A. Modified auger s/s complete 11 tooth sprocket (P/N 703250)

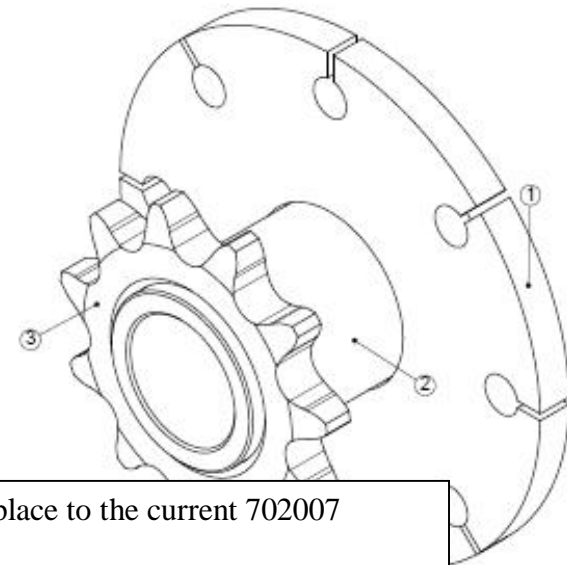
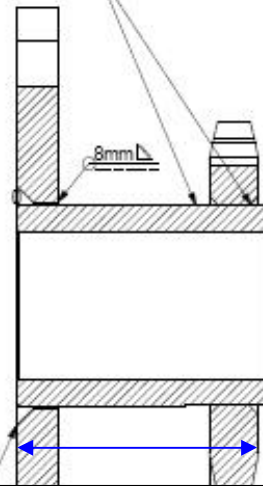
7mm  Use only 307 Si stainless steel filler wire

4mm + 5mm  Ensure that weld does not protrude past flange face

115mm = it is possible to replace to the current 702007 (115mm auger s/s)

95mm = **must fit**

B. old type auger stub 701892 (old no.EF109-10) & 11 t/s/s EF109-13 (*No longer supplied as parts*)
